APPLICATION FOR ZONING CHANGE

Date 2-25-91NAME OF PROPOSED DEVELOPMENT Steger Retail AdditionLOCATION OF PROPOSED DEVELOPMENT N.E. corner of FM 740 and
FM 3097NAME OF PROPERTY OWNER/DEVELOPER Estate of O.L. Steger, Jr. and Emily Sue
Whitehead
c/o Lakeside National BankADDRESS P.O. Box 9PHONE (214) 771-8311Rockwall, Texas 75087NAME OF LAND PLANNER/ENGINEER Winkelmann & Associates, Inc.ADDRESS 12800 Hillcrest Road, Suite 200PHONE (214) 490-7090Dallas, Texas 75230TOTAL ACREAGE 4±CURRENT ZONING ANUMBER OF LOTS/UNITS 1PROPOSED USE FOR DEVELOPMENT Grocery Store

FOOD LION, INC. SITE #50a
F.M. 740 @ F.M. 3097
Rockwall County
Rockwall, Texas

JOB NO.	91-06
DATE	3-19-91
DRAWN	M.T.B.
CHK	J.D.H.
SHEET	A-3
OF 19	
EXTERIOR ELEVATIONS	
3390-DB 1Z

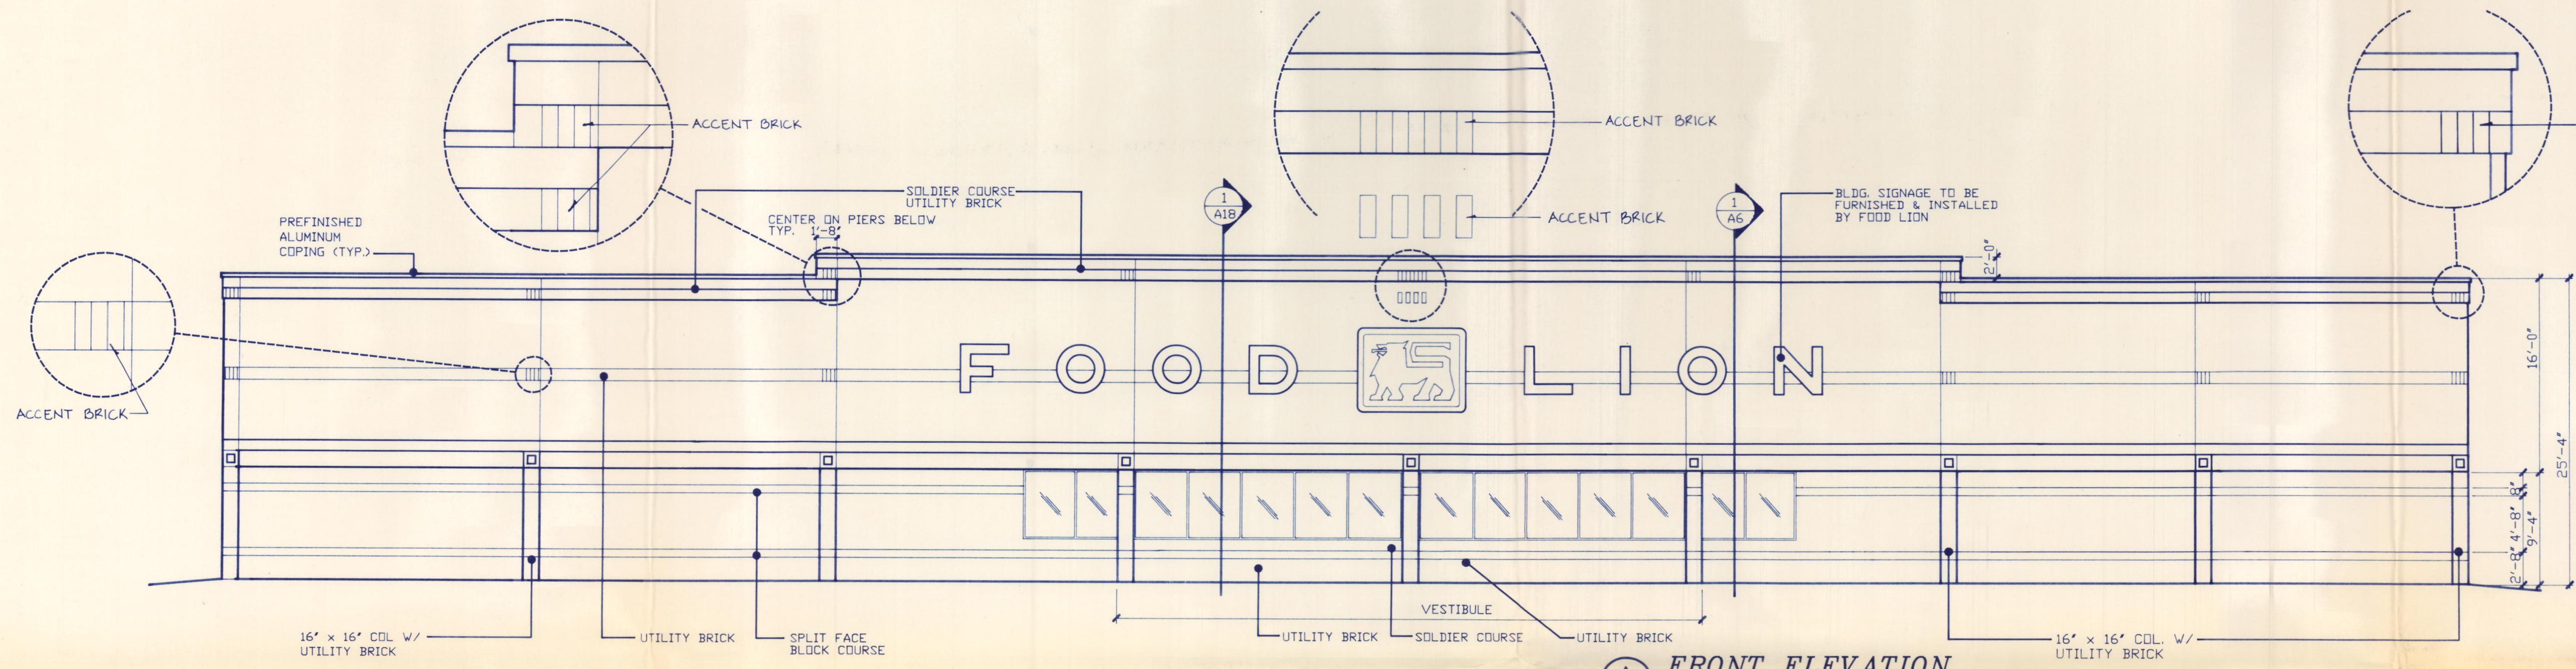
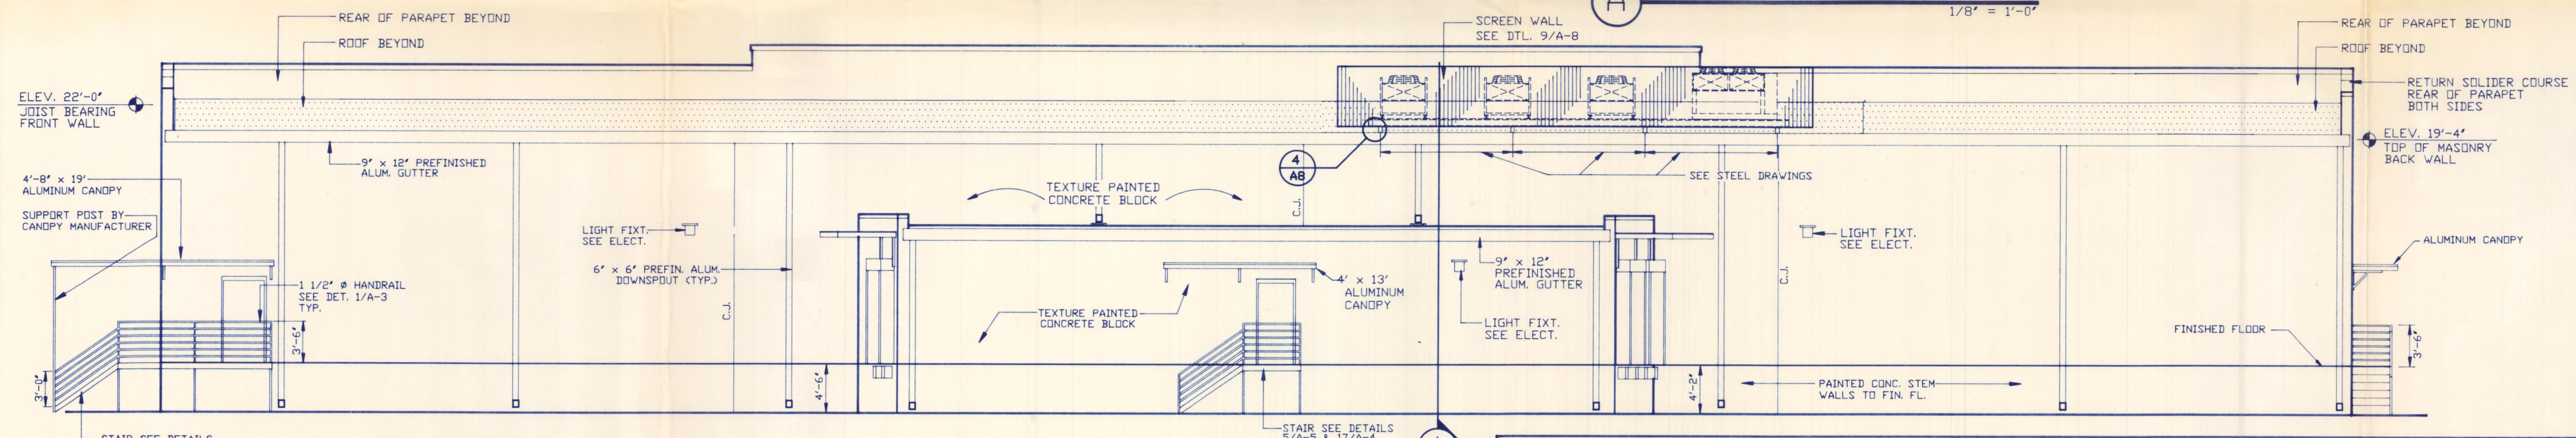
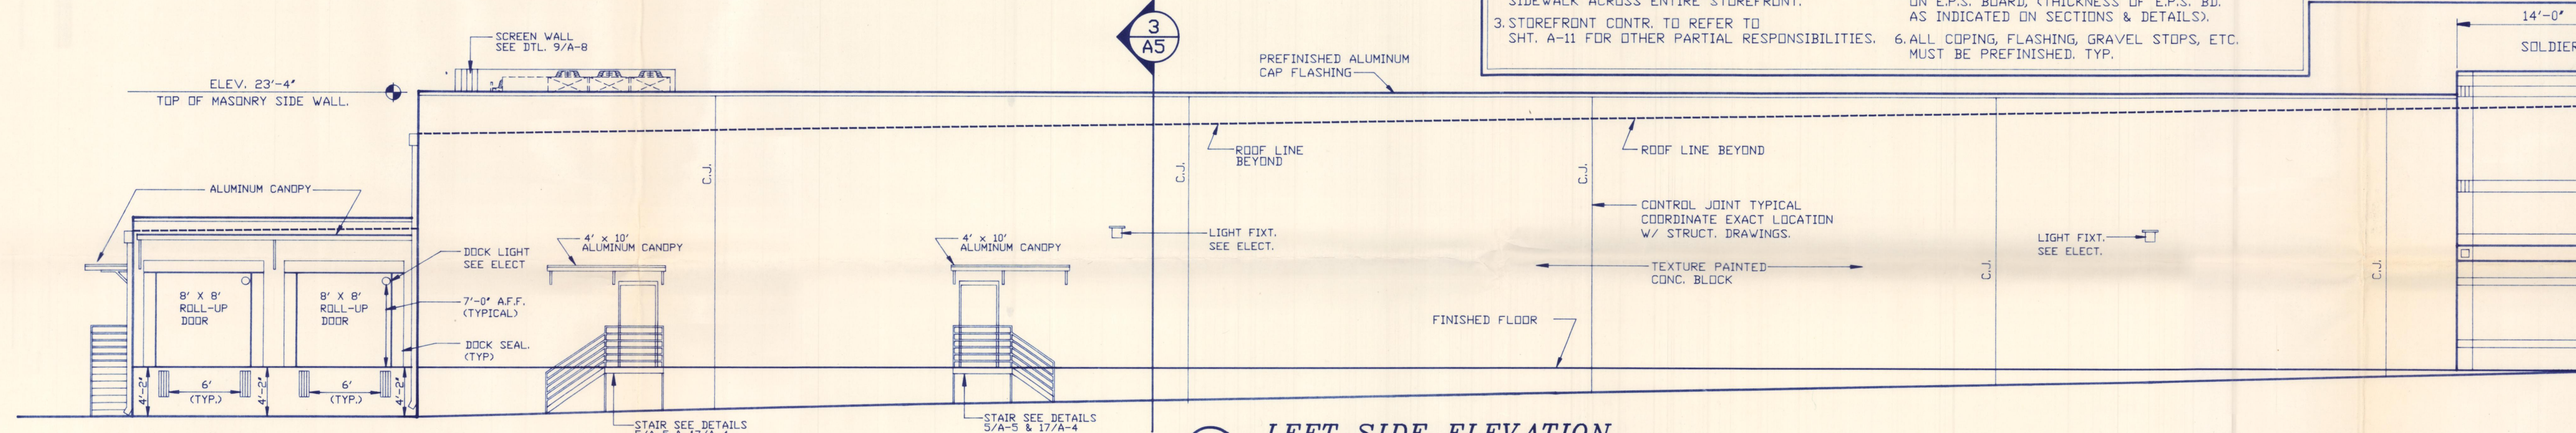
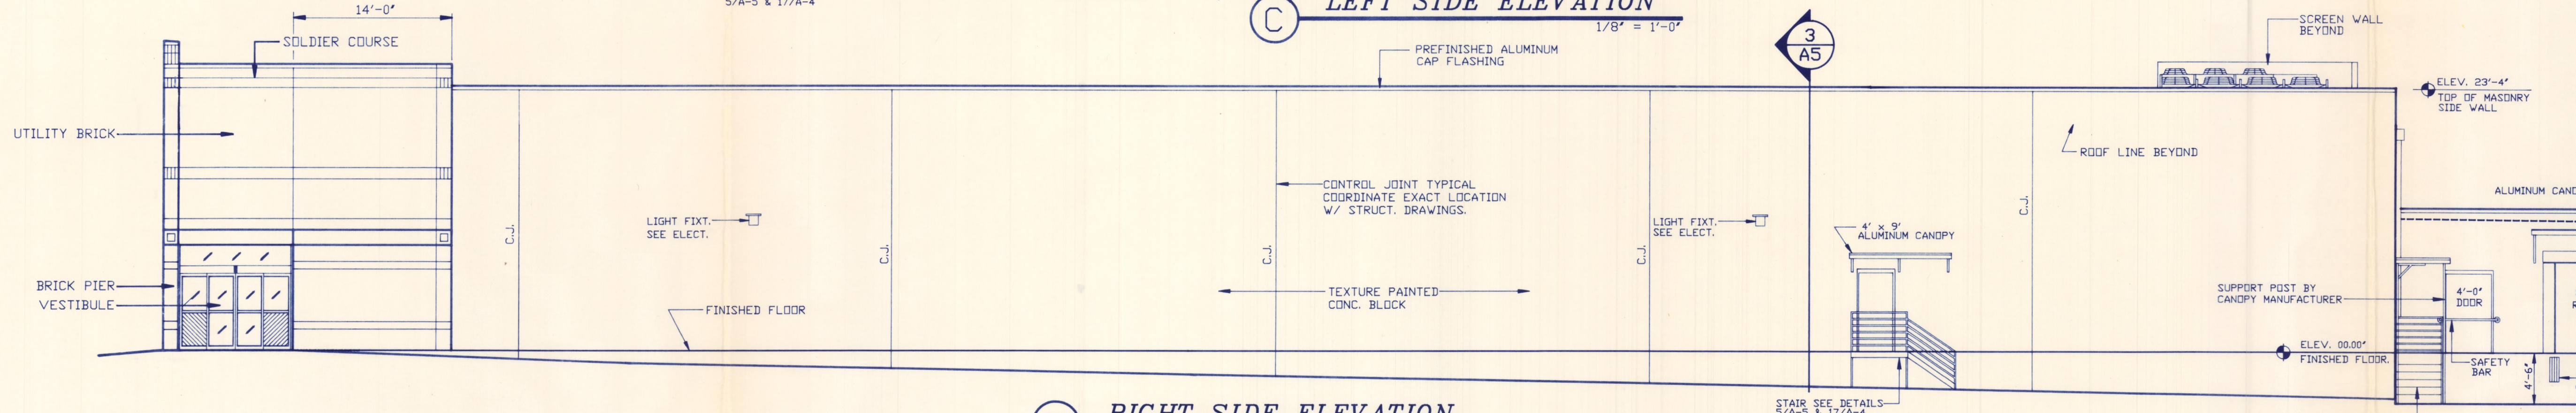
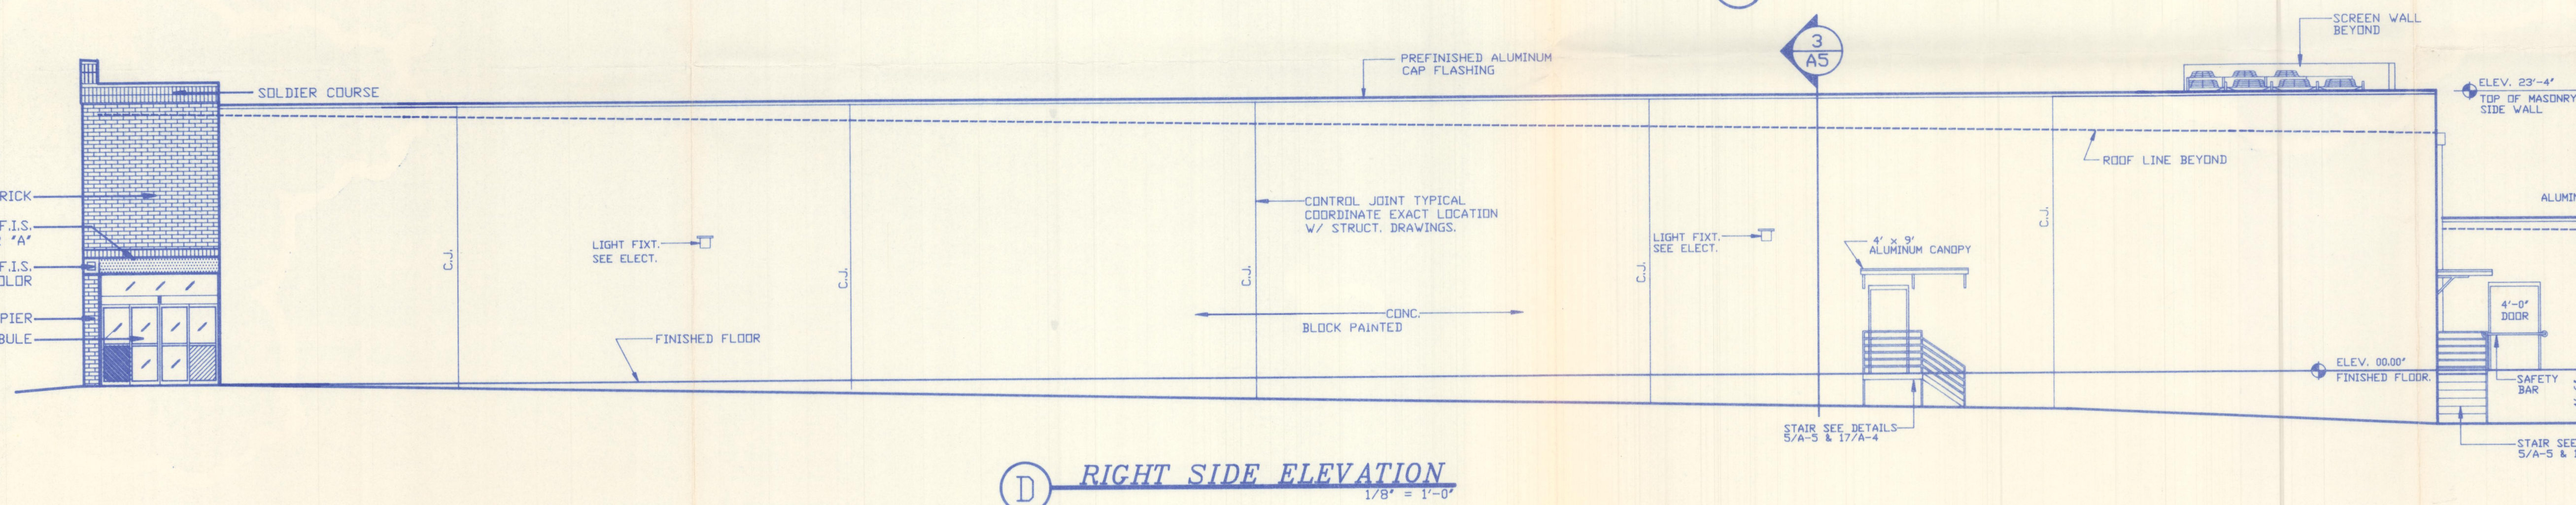
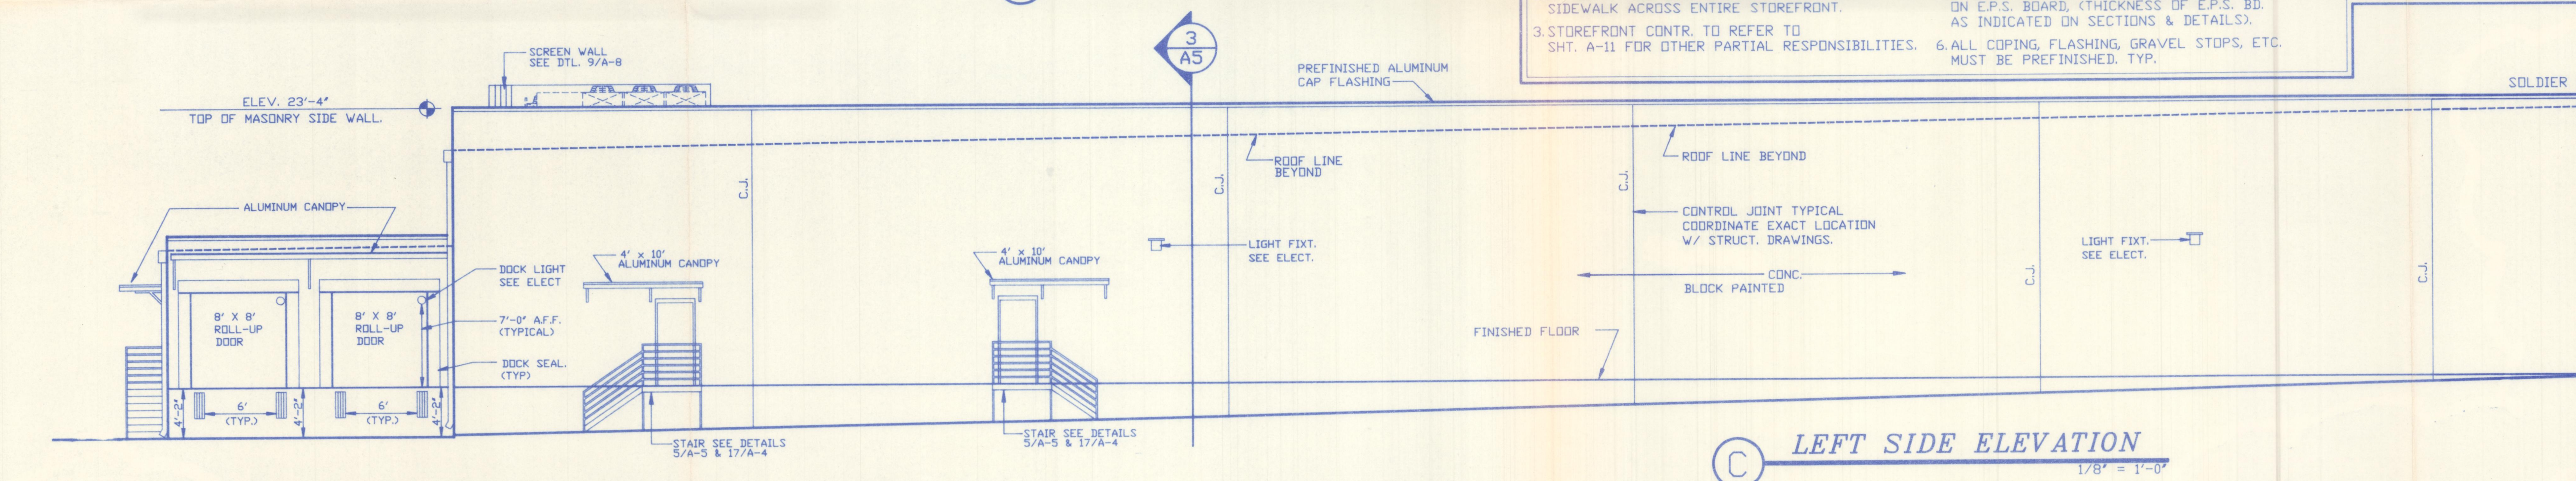
add windows & color to top &
Bottom on front elevations

add Brick to 8+18 on both sides

1. The building facade in front is not like the facade approved at the other location. The previous location included a taller front parapet with wrap around brick to give the facade more substance. The Commission will want to know why this change was made. One of the purposes of the wrap around on the sides was to help screen the roof mounted deli utility equipment. Will this equipment be used in this building?

2. What type of roof mount screen will be used around the utility equipment to the rear and will that screen be used on three sides?
3. The previous plan included brick around all four sides of the building. This location will not have the visibility of the previous location but the sides will be totally visible until there is additional development. Even when additional development occurs some of the sides will continue to be visible. The Commission expressed some concern about this issue. There is additionally no guarantee that future buildings will be located adjacent to this building. The Commission also expressed concern about the use of concrete block. There was some discussion about a stucco type paint material that might be used to surface the block. You need to be prepared to discuss this issue at the Architectural Review meeting as I am sure that it will be raised.

4. Please identify the material for the screens around the dumpster locations. It generally should match the material on the main structure.
5. Will the stairs in the rear be of the same bronze color as the coping along the top of the building? They were planned to match under the previous plan.

6. The front wall of the entry vestibule is on the same vertical plane as the front facade. The remainder of the front facade is supported to either side of the vestibule by brick piers. This provides for a covered sidewalk 12'-0" wide at either side of the entry vestibule.
